TO: Mercedes-Benz Dealer Principals, General Managers, Sales Managers, Service Managers, Parts Managers	FROM: Gregory Gunther, Department Manager, Vehicle Compliance and Analysis, Engineering Services
RE: Recall Campaign Launch Notification Check the Power Steering Supply Connection MY20 CLA-Class (118 platform)	DATE: 12/28/2021

Campaign No. 2021120016,
December 28th, 2021

SUBJECT: **Model CLA-Class (118 platform)**
Model Year 2020

Check the Power Steering Supply Connection

Figure 1

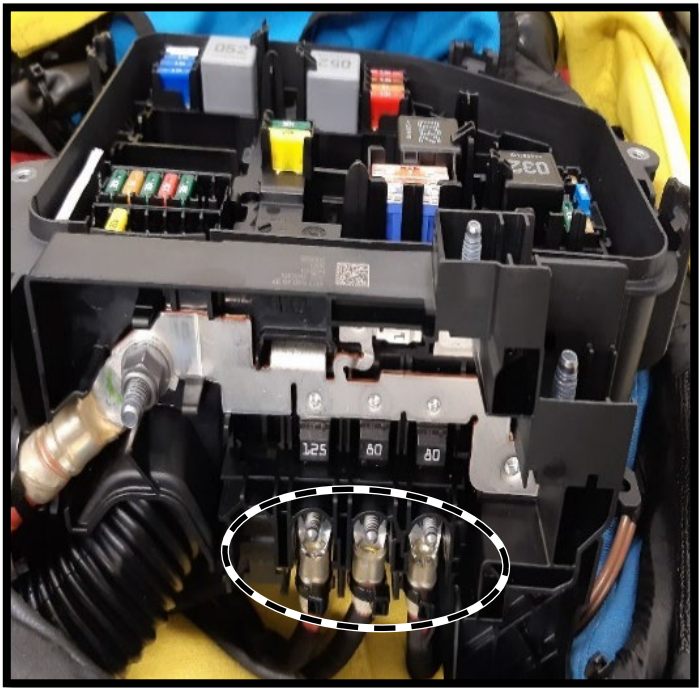
1. Disconnect ground line of battery (**AR54.10-P-0003MFA**).
2. Remove cover from fuse box/prefuse box at front.
i For basic data, see **AR54.15-P-1330MFA**.
3. Remove cable ties and loosen all threaded connections individually in succession on prefuse box (marking, **figure 1**)
i Depending on the equipment variant, there may be more or fewer cables present (marking, **figure 1**).
